Title of Change:	Dual Cool Packages New Marking Lay-Out
Effective date:	01 Sep 2023
Contact information:	Contact your local onsemi Sales Office or KrisJudelo.Dayna@onsemi.com
Type of notification:	This Product Bulletin is for notification purposes only. onsemi will proceed with implementation of this change upon publication of this Product Bulletin.
Change Category:	Assembly Change
Change Sub-Category(s):	Shipping/Packaging/Marking

Description and Purpose:

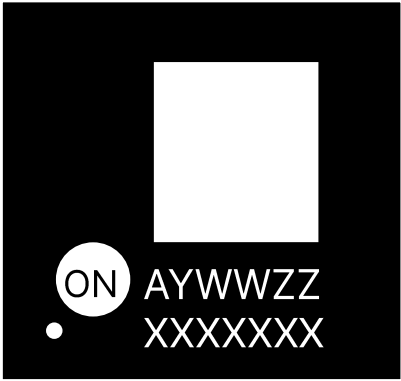
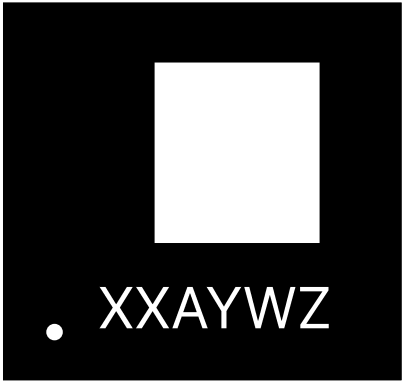
In order to improve quality of marking and its legibility, we are moving towards simplification of the layout. Below is the summary of the changes.

From	To
Logo	Yes	No
Pin 1	Yes	Yes
Plant Code	Yes (A)	Yes (A)
Date Code	Yes (YWW)	Yes (YW)
Lot Code	Yes (ZZ)	Yes (Z)
Device Mark	Yes (XXXXXX)	Yes (XX)

Please note that "ON" logo will be removed on the new layout.

ZZ – 2 digit lot code sequence per starts with AA, AB, AC, AD, etc.

Z – 1 digit lot code sequence starts with A, B, C, D, etc.
